UNITED STATES PATENT AND TRADEMARK OFFICE

APPLICATION NO.	FILING DATE	FIRST NAMED INVENTOR	ATTORNEY DOCKET NO.	CONFIRMATION NO.
10/657,934	09/09/2003	Barry Wixey	TN-2347B	1594
7590 Adan Ayala, Esq. Black & Decker Inc. 701 E. Joppa Road, TW-199 Towson, MD 21286		03/09/2007	EXAMINER SELF, SHELLEY M	
			ART UNIT	PAPER NUMBER
			3725	
SHORTENED STATUTORY PERIOD OF RESPONSE		MAIL DATE	DELIVERY MODE	
3 MONTHS		03/09/2007	PAPER

Office Action Summary	Application No.	Applicant(s)
	10/657,934	WIXEY ET AL.
	Examiner Shelley Self	Art Unit 3725

DETAILED ACTION

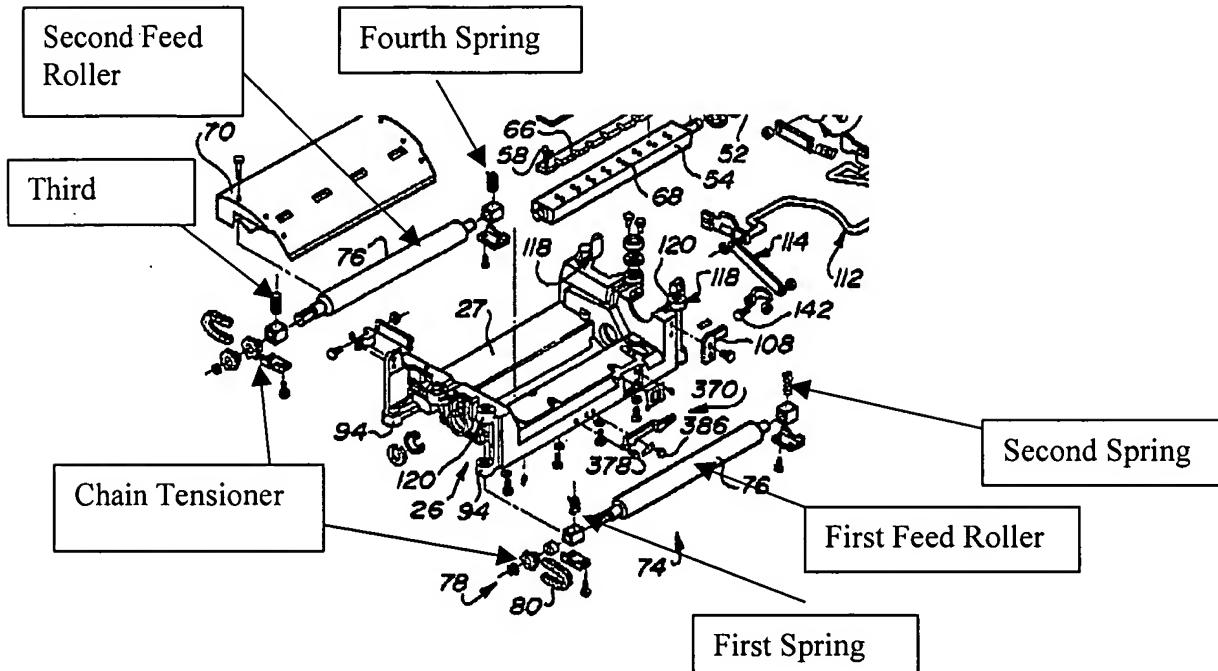
With regard to claim 2, Welsh discloses the switch and hand crank on the same side half. Examiner notes the switch and hand crank on the same half of the planer half is defined as that split along the longitudinal length of the planer.
